SUNDALE DEVELOPMENTS

12-16 BENT STREET - LINDFIELD

LANDSCAPE RESPONSE TO SDRP REVIEW 2 (2 APRIL 25)

S24-01924 • 25/09/2025

On-Structure Soil Depth Plan

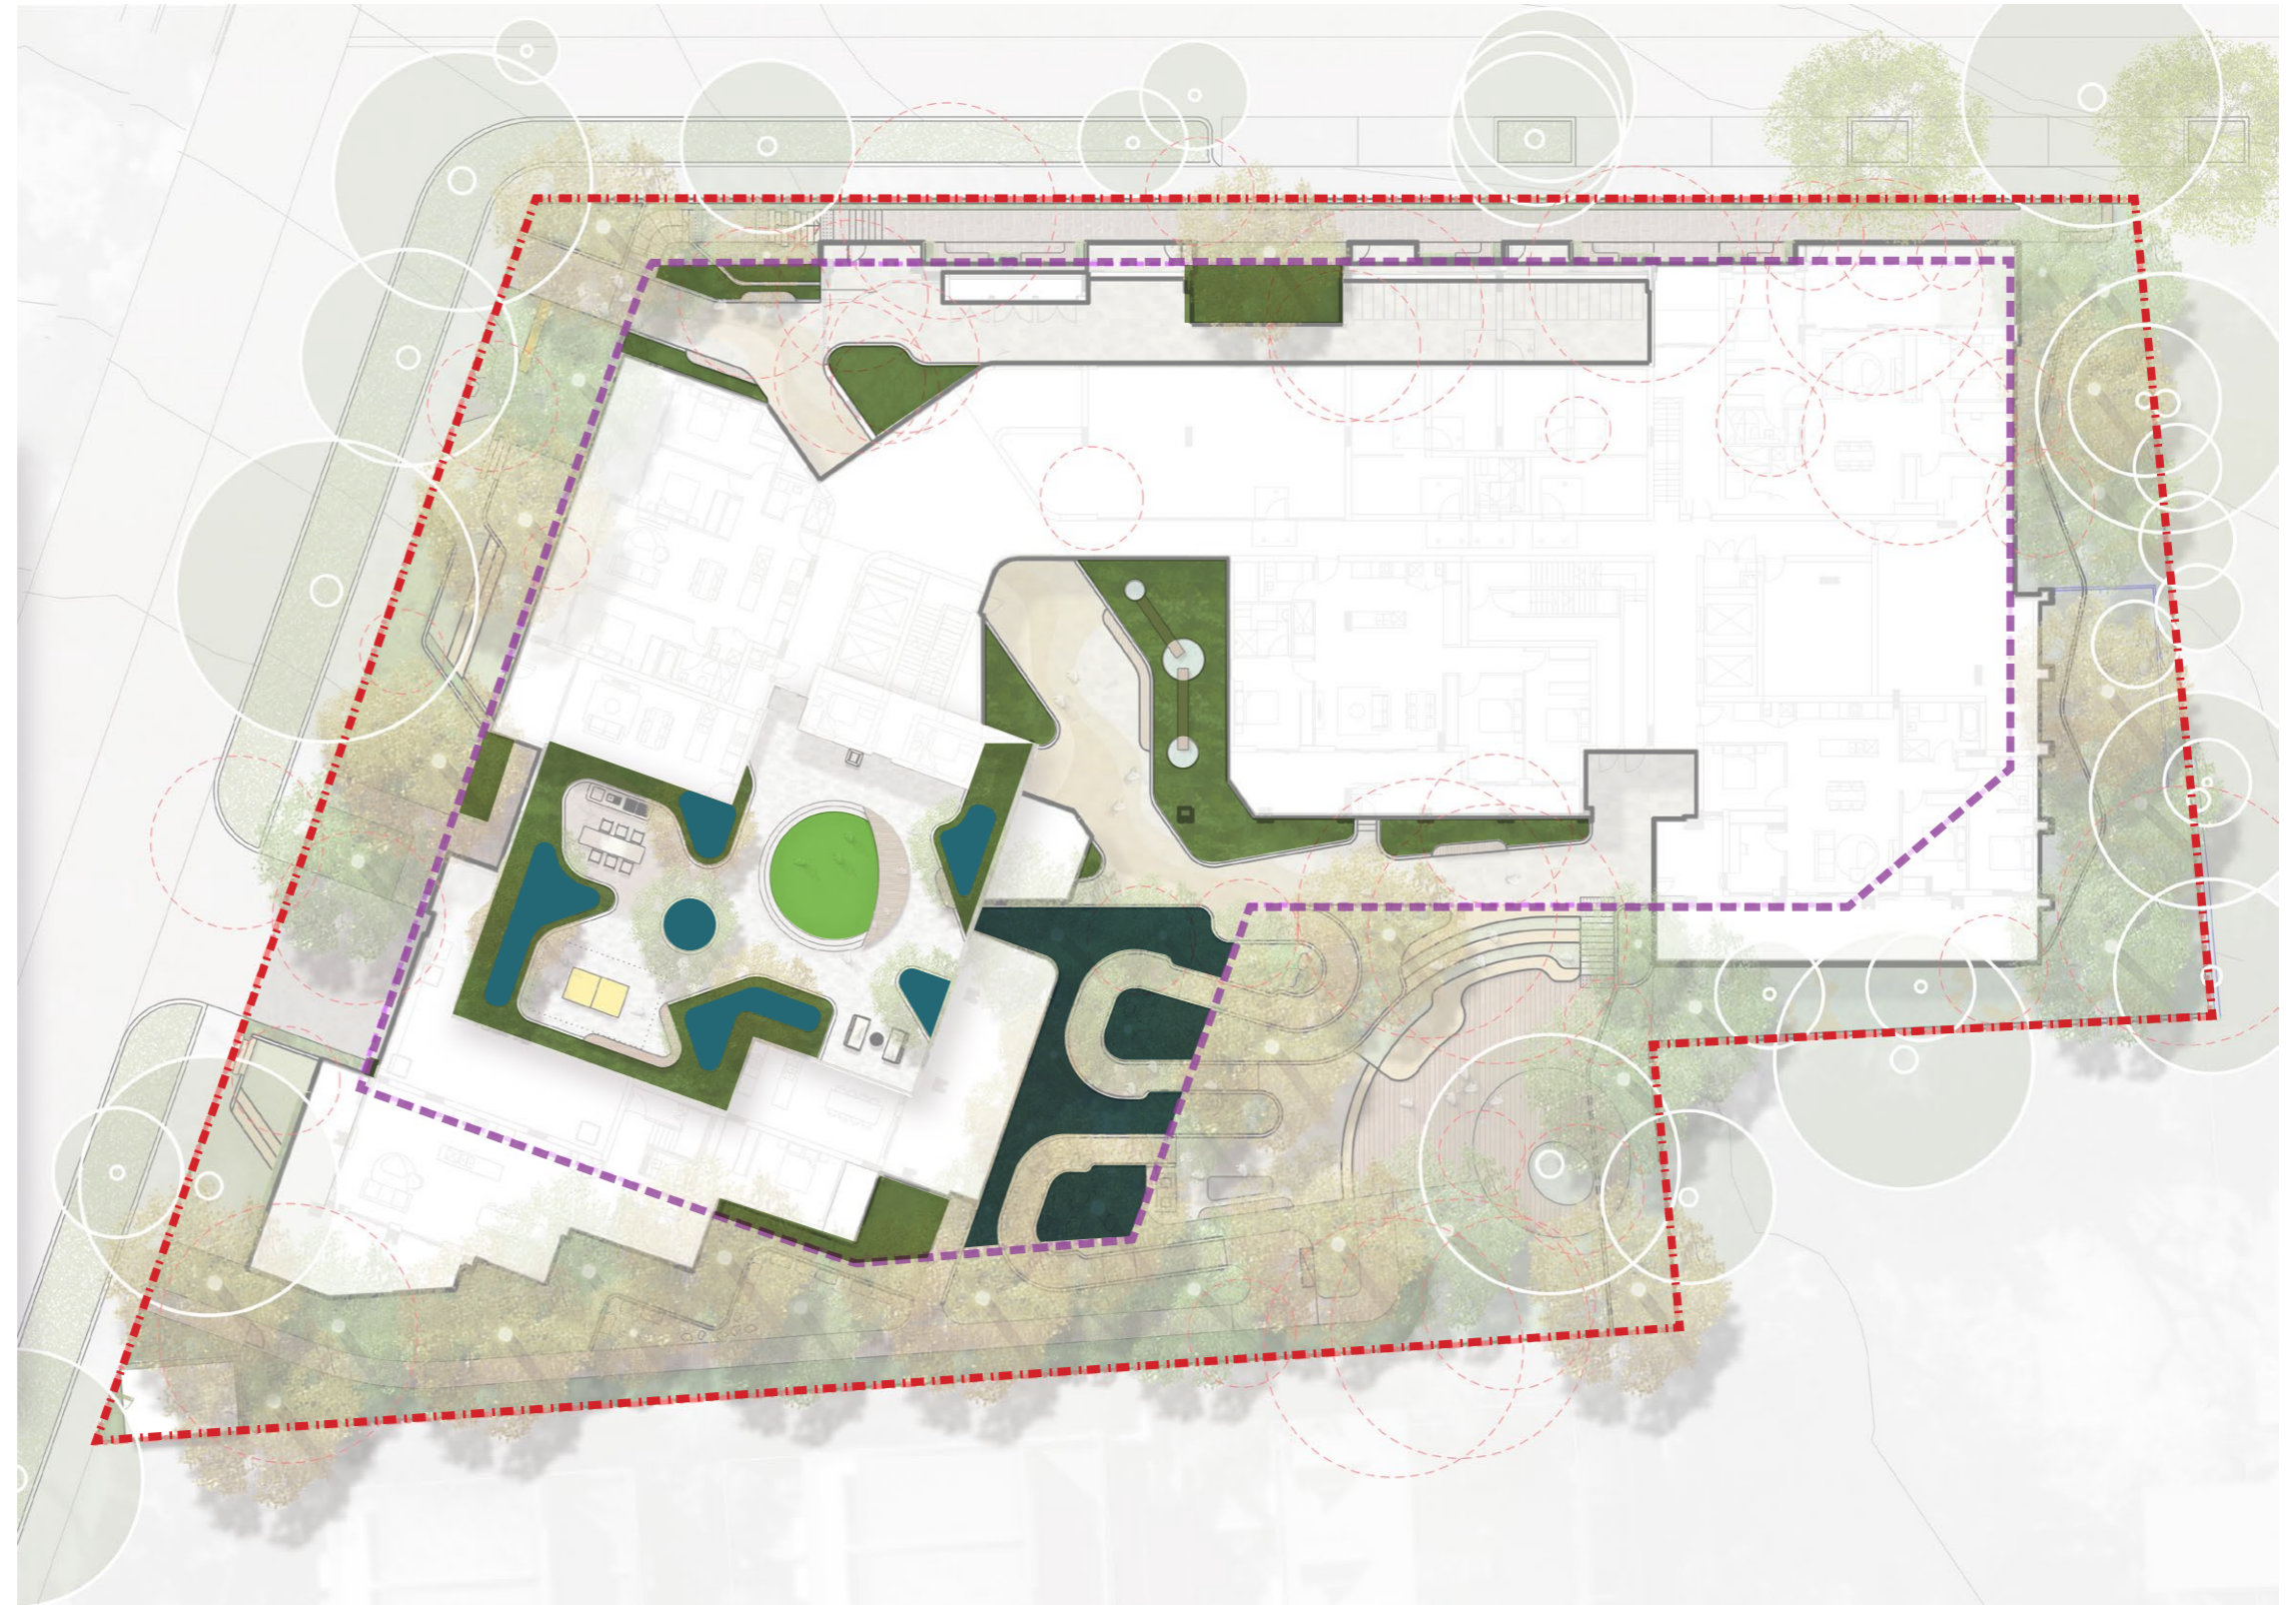
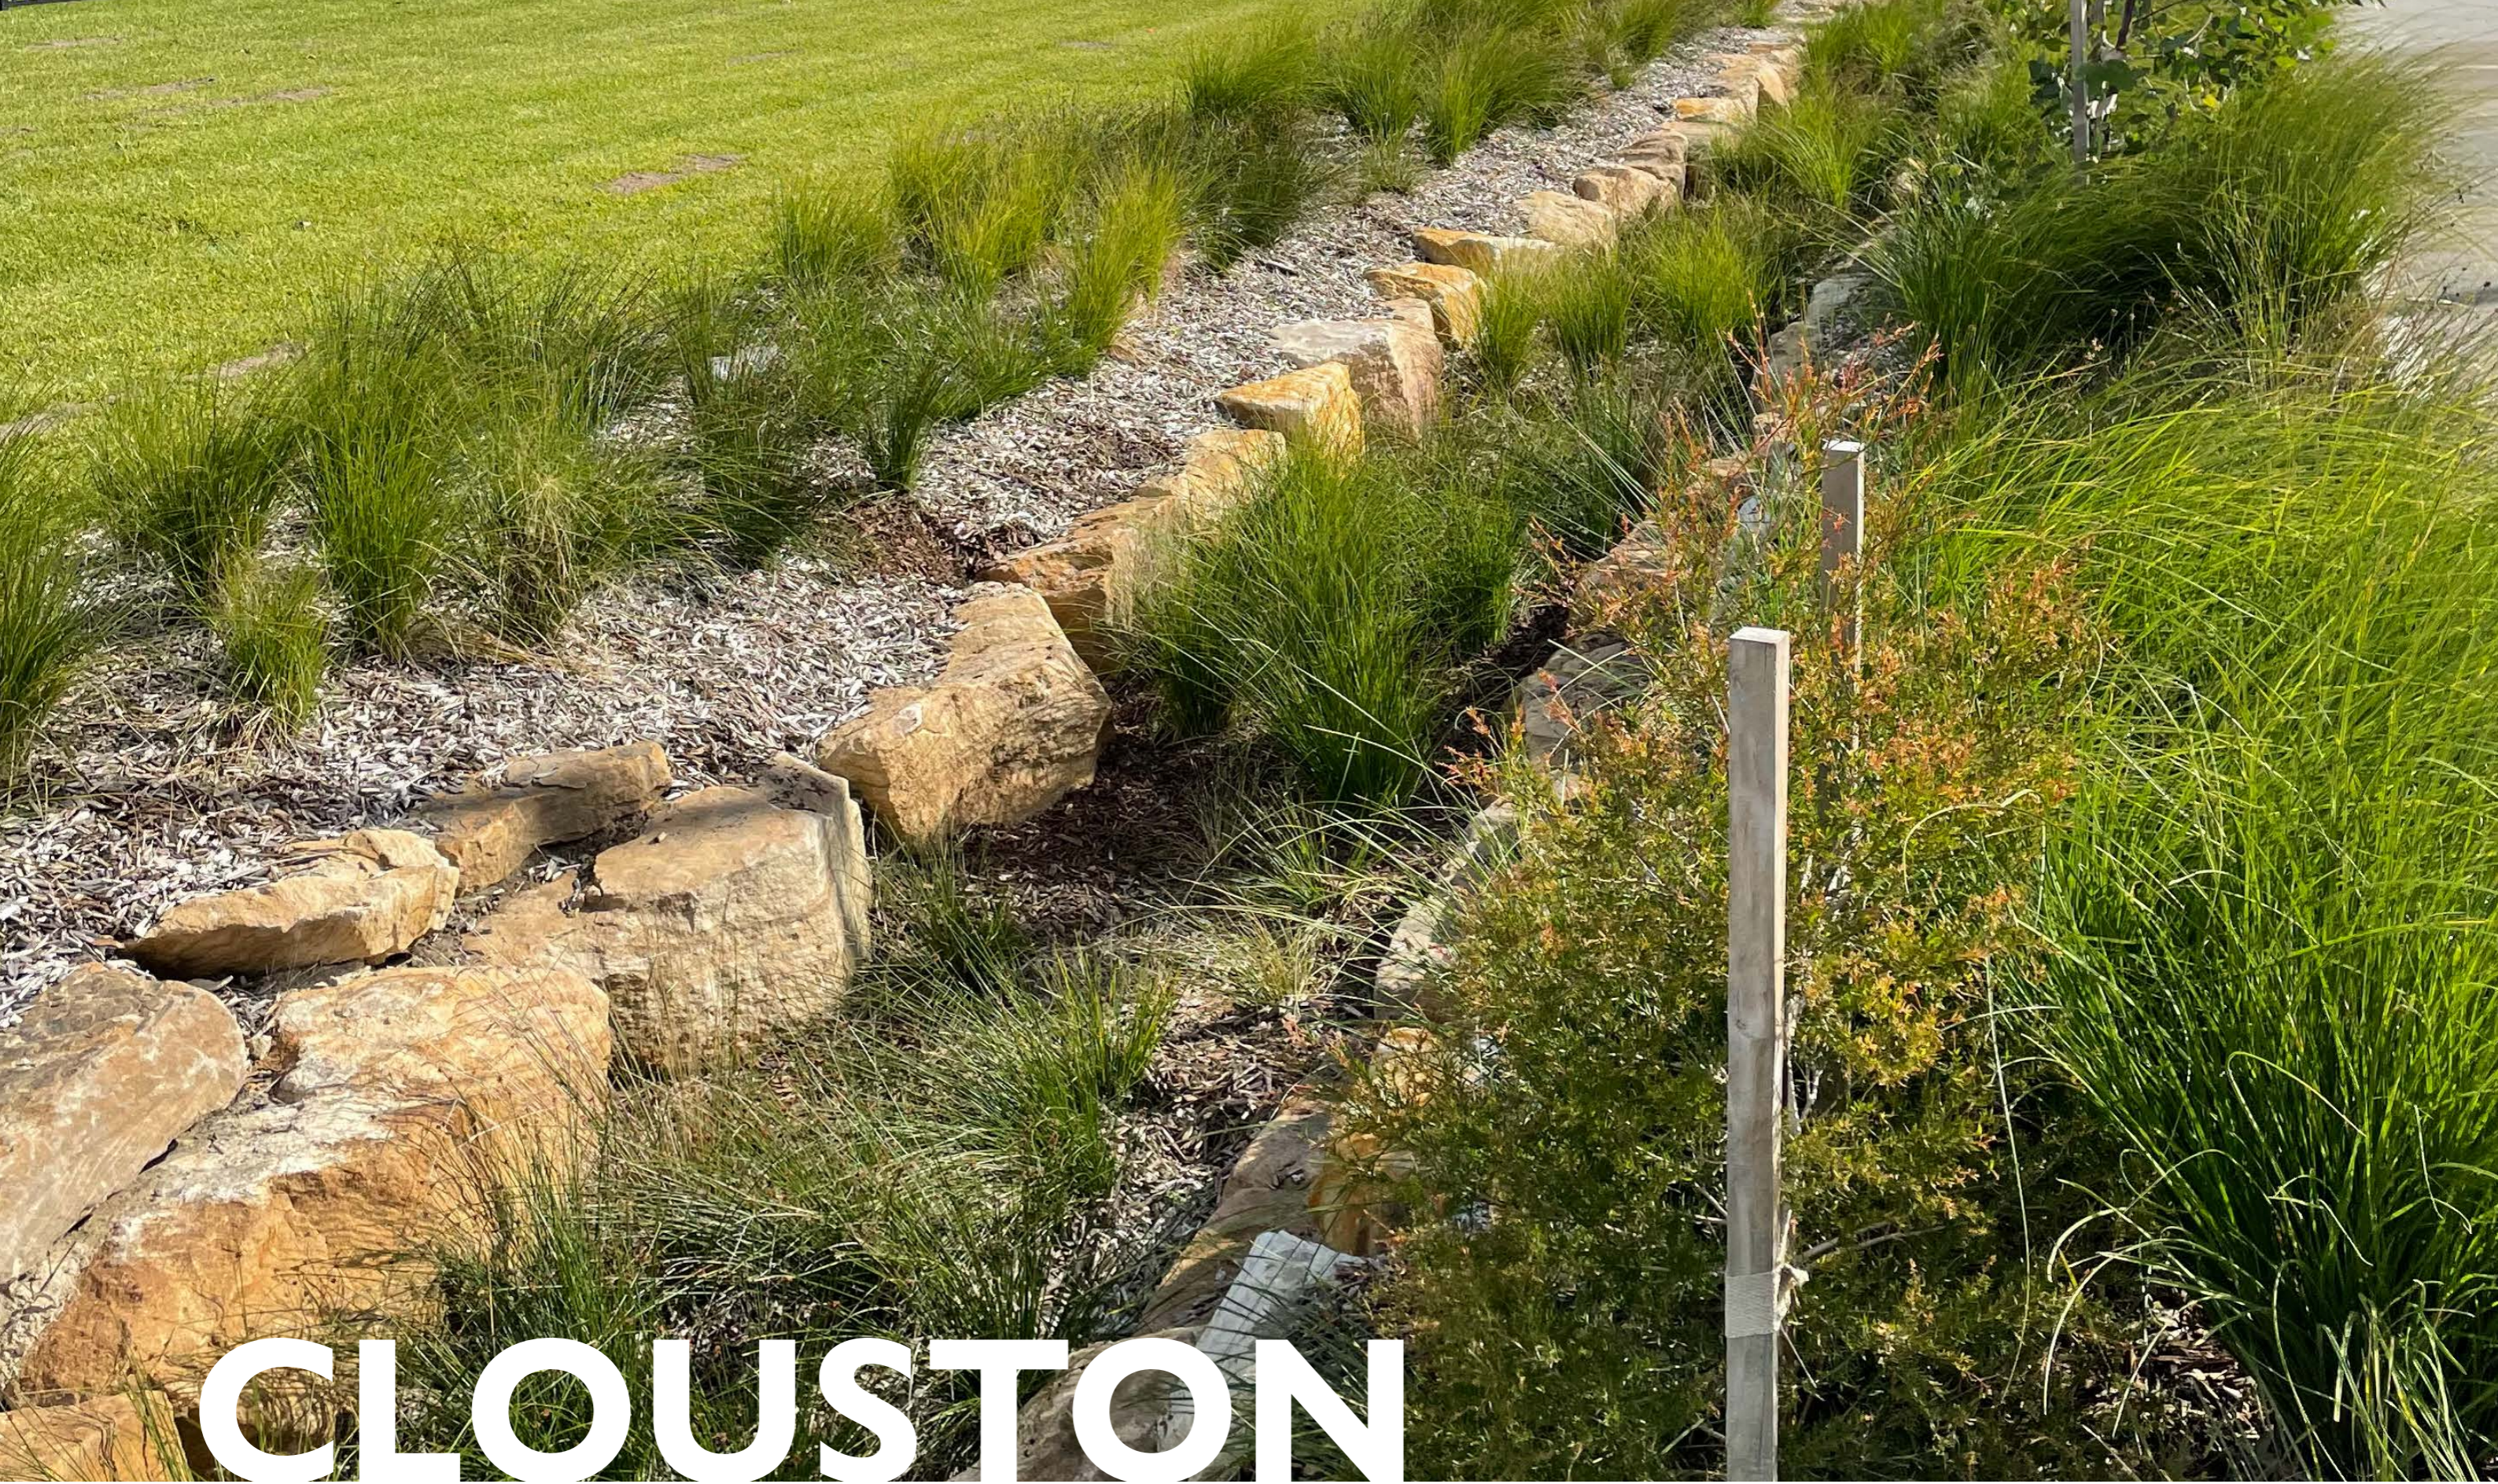
- Demonstrate that adequate soil depth is provided for all planting on the structure to support the intended landscape design.

- As per ADP 's requirements, the design ensures that all planting on structure has sufficient soil depth:
1. Large trees – minimum 1200mm deep soil
 2. Medium trees – minimum 1000mm deep soil
 3. Small trees – minimum 800mm deep soil
 4. Shrubs – minimum 500-600mm deep soil
 5. Ground cover – minimum 300-450mm deep soil
 6. Turf – 200mm deep soil
